MPC Paper No. A/H6/89A
For Consideration by the
Metro Planning Committee
on 24.4.2020

**APPLICATION FOR PERMISSION
UNDER SECTION 16 OF THE TOWN PLANNING ORDINANCE**

APPLICATION NO. A/H6/89

- Area shown as 'Road' – about 217m² (about 5%)
- Application** : Proposed 'Office', 'Eating Place' and 'Shop and Services' uses

PLAN
A - 2

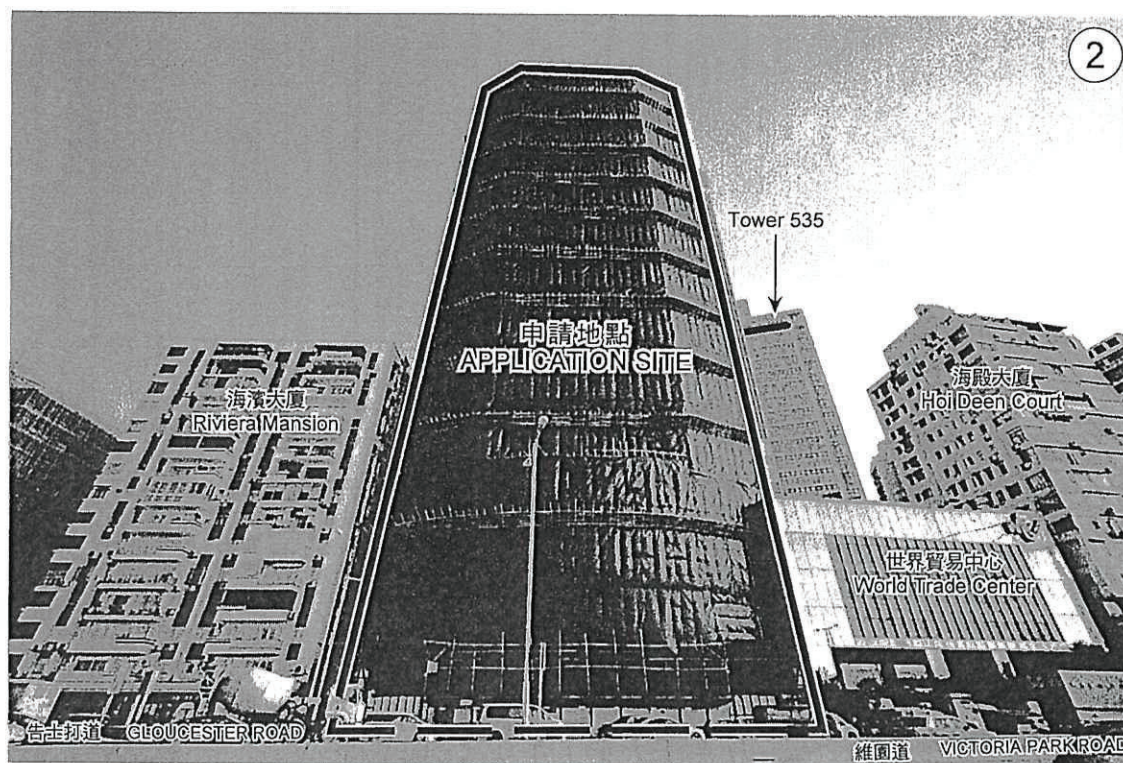
- (k) the application site boundary was indicated in Plan A-2, and the northern part of the proposed development fronting Gloucester Road encroached into an area shown as 'Road' on the OZP. Similarly, the northern part of World Trade Centre fronting Gloucester Road also encroached into an area shown as 'Road' on the OZP; and
- (l) heavy goods vehicles (HGVs) would access the proposed development at Jaffe Road where three loading/unloading (L/UL) spaces for HGV were designated. The applicant advised that staff would be deployed to oversee the future operation of the L/UL spaces. TD advised that the main vehicular access should be at Gloucester Road rather than at Jaffe Road which was a narrow road where vehicular activities should be kept at the minimal.
